TENDER NO. KGN-SBP-02-2018

KENYA ELECTRICITY GENERATING COMPANY

TENDER FOR DESIGN, SUPPLY, INSTALLATION, TESTING AND COMMISSIONING OF SMART SOLAR GRID-TIE SYSTEM FOR KIPEVU OFFICE BLOCK, INTEGRATED SOLAR STREET LIGHTING AND LED RETROFIT MAST LIGHTING AT KIPEVU

CLARIFICATION No .1

Roof Orientation

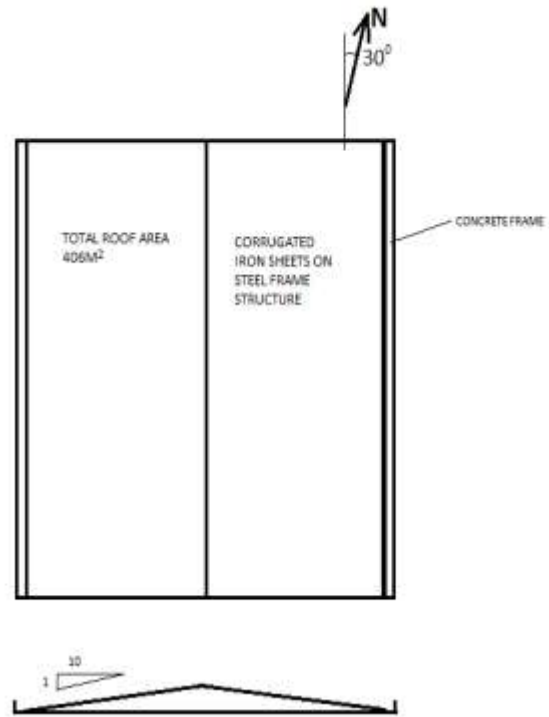
3.	Could you please share the specifications of the grid-tie solar system (required capacity, connected loads and load profile to work on the system's design)?	Item 3, we are sending an addendum on the sizing. The load profile will be shared in the site visit.

Based on the requirements reviewed for this schedule, KenGen would like to issue the following clarification with regards to scope of work:
Based on the load requirement for the kipevu power station office block, the grid tie system sizing shall be of 40kW grid-Tie. Please take note of the following additional information:

ITEM	SPECIFICATION
System Load	40 kW
Roofing Area	406 M ²
